COUNTY OF HARNETT
Building Inspections Department
Planning Services

ADDRESS : 19 DERBY LN SUBDIV: JOHNSON FARMS 34 LOTS
 CONTRACTOR : GARY ROBINSON HOMES LLC PHONE : (910) 977-2562
 OWNER : INVESTMENT CHOICES LLC PHONE :
 PARCEL : 11-0661- - -0100- -68-
 APPL NUMBER: 14-50034735 CP NEW RESIDENTIAL (SFD)

STRUCTURE: 000 000 44X40 3BDR 2.5BATH SFD W GAR DECK SLAB

Fig. 3. Foundation Wall Base

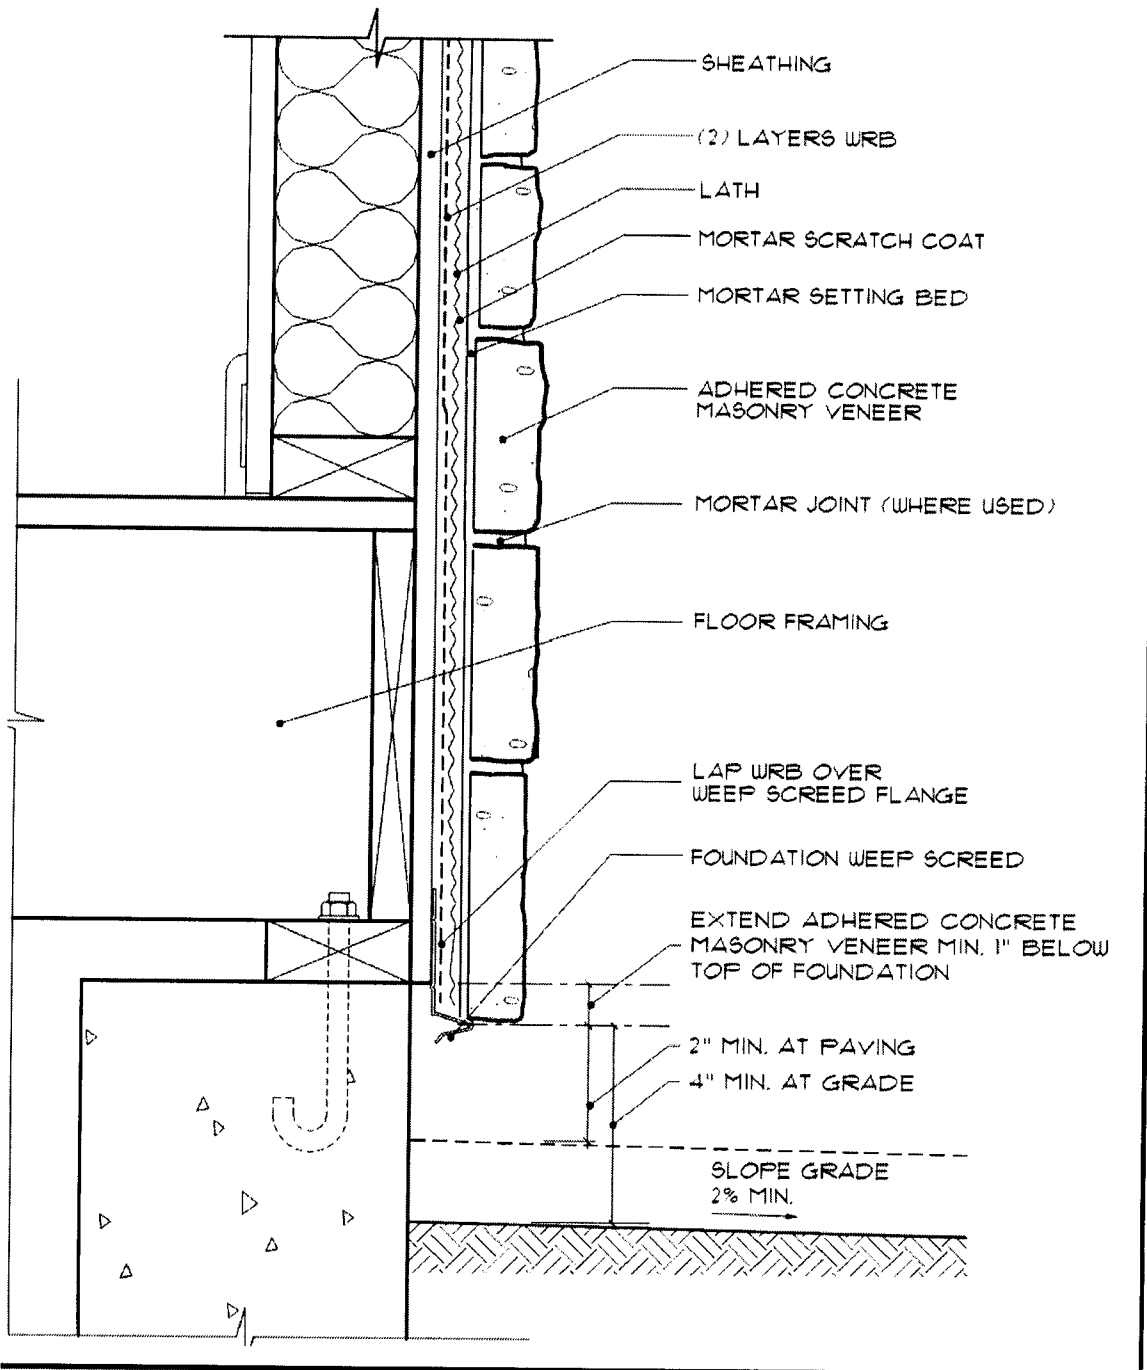
A minimum 4" gap is required at the base of the stud wall to grade and a minimum 2" gap is required at base of the stud wall over paved surface.

Keywords: "shall", "screeds", "2 inches above paved areas", "4 inches above earth"

"R703.6.2.1 Weep screeds. A minimum 0.019-inch (0.5 mm) (No. 26 galvanized sheet gage), corrosion-resistant weep screed or plastic weep screed, with a minimum vertical attachment flange of 3 1/2 inches (89 mm) shall be provided at or below the foundation plate line on exterior stud walls in accordance with ASTM C 926. The weep screed shall be placed a minimum of 4 inches (102 mm) above the earth or 2 inches (51 mm) above paved areas and shall be of a type that will allow trapped water to drain to the exterior of the building. The weather-resistant barrier shall lap the attachment flange. The exterior lath shall cover and terminate on the attachment flange of the weep screed."
